Project	IEEE 802.16 Broadband Wireless Access Working Group < http://ieee802.org/16 >
Title	Correction of Ranging Primitive Example
Date Submitted	2006-11-06
Source(s)	Jaesun Cha and Chulsik Yoon jscha@etri.re.kr ETRI 161 Gajeong-dong, Yuseong-gu Daejeon 305-700 Korea
Re:	Contribution on comments to IEEE 802.16g/D5
Abstract	Correction of ranging primitive example
Purpose	Adoption
Notice	This document has been prepared to assist IEEE 802.16. It is offered as a basis for discussion and is not binding on the contributing individual(s) or organization(s). The material in this document is subject to change in form and content after further study. The contributor(s) reserve(s) the right to add, amend or withdraw material contained herein.
Release	The contributor grants a free, irrevocable license to the IEEE to incorporate text contained in this contribution, and any modifications thereof, in the creation of an IEEE Standards publication; to copyright in the IEEE's name any IEEE Standards publication even though it may include portions of this contribution; and at the IEEE's sole discretion to permit others to reproduce in whole or in part the resulting IEEE Standards publication. The co

Figure F9 – The use of Ranging Primitives

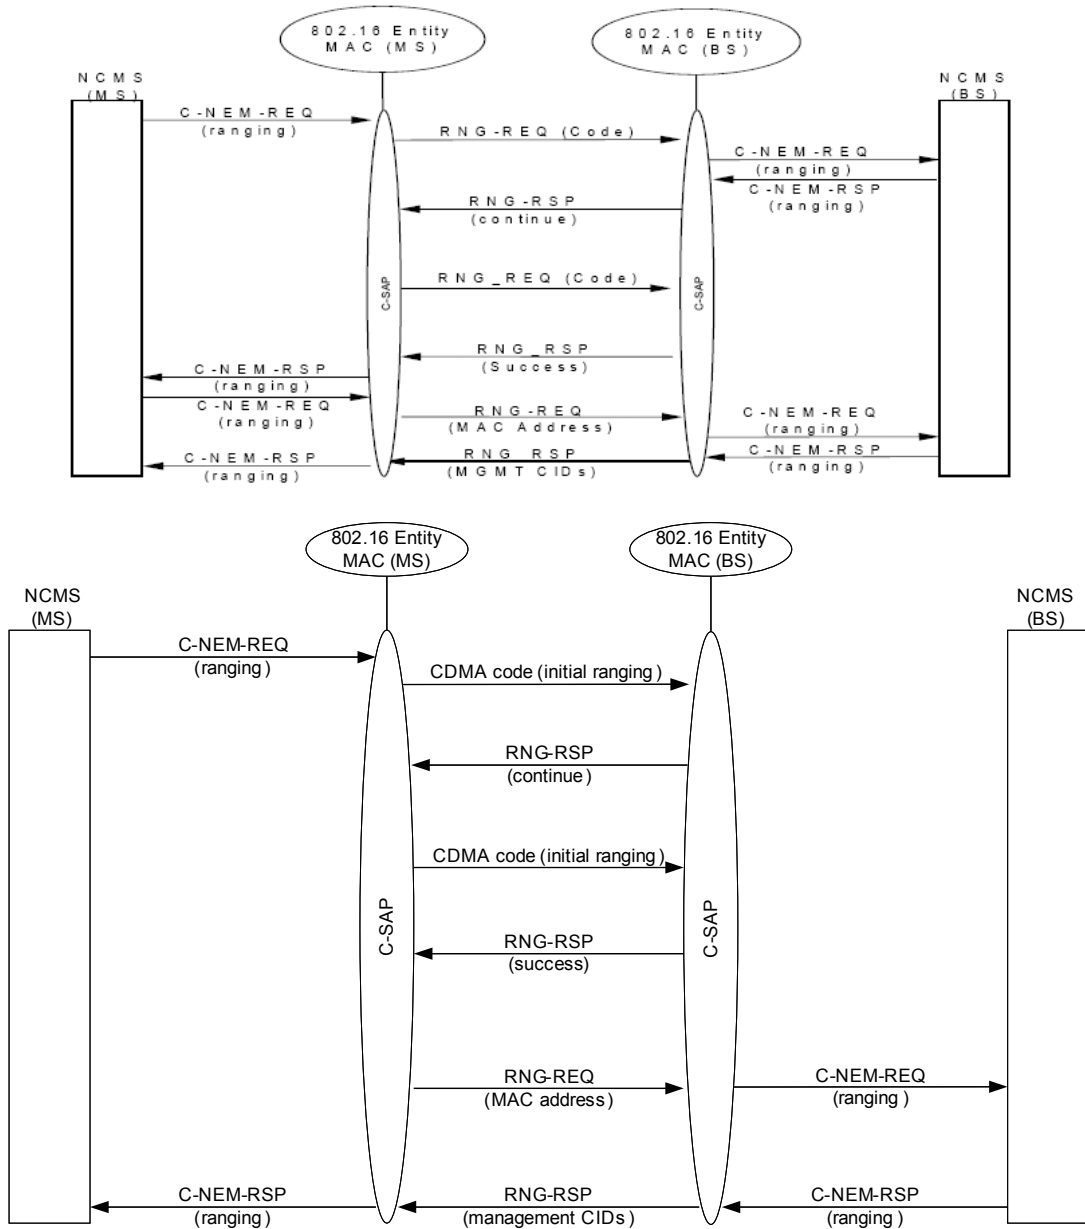
Figure F9 shows how ranging primitives can be used when 802.16 device performs initial ranging. According to the Figure, NCMS at MS and BS participates in code-based ranging as well as message-based ranging procedure.

Because NCMS is a high-level logical entity and code-based ranging is a pure MAC-layer function, it is not a good approach for NCMS to participate in code-based ranging procedure. Only thing that NCMS needs to do is to trigger code-based ranging procedure.

In addition, NCMS doesn't need to manage parameters included in RNG-RSP sent to MS as a response to CDMA code for initial ranging because only BS can manage those parameters (timing off adjustment, frequency adjustment, power level adjustment, etc) related with air interface.

[Modify F.4 Ranging Primitives Usage as follow]
